CAPITOL ZONING DISTRICT COMMISSION
STAFF REPORT
11/23/16
BIM / TDM

Location: 2428-30 South Louisiana Street
Applicant: Matt Foster for Little Rock Historic Properties
Permit Type: Certificate of Appropriateness

Description: This project calls for a full rehabilitation of the house and detached garage. Most of the proposed work (eg. repair / replace windows, roofing, and masonry with like materials) can be approved at the staff level. Items requiring Commission review include reconstructing and enclosing the rear porch as an enclosed living space; replacing the brick front porch columns with wood columns; installing front porch pendant lights; and removing the rear chimney.

EAST AND SOUTH ELEVATIONS

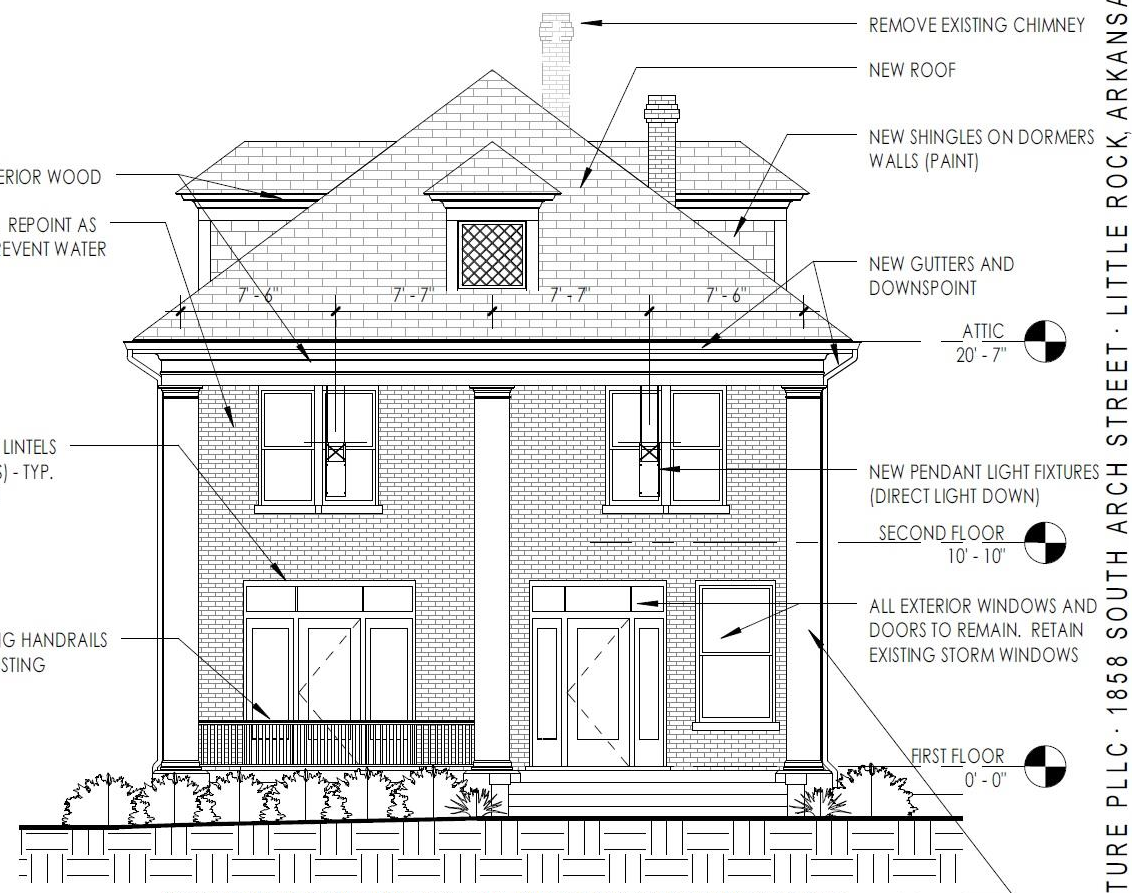
Staff finds that the proposal to replace the historic brick columns with wood columns is NOT consistent with this standard.

Front porch: Staff finds the proposal is NOT consistent with this standard. Though written in regards to whole porch replacement, staff believes this standard is also applicable to individual porch elements. Staff believes the proposed wood replacement columns do not match the originals. Staff moreover believes the proposed pendant light fixtures represent a decorative element not known to have been used on such houses.

Staff finds the proposal to replace the front porch columns is NOT consistent with these standards.

Staff Recommendation: Based on the above findings, staff recommends **denial** of the proposal to replace the front porch columns with wood and install the proposed decorative pendant lights, and staff recommends **approval** of the proposed rear porch reconstruction and enclosure and the removal of the rear chimney with the following conditions:
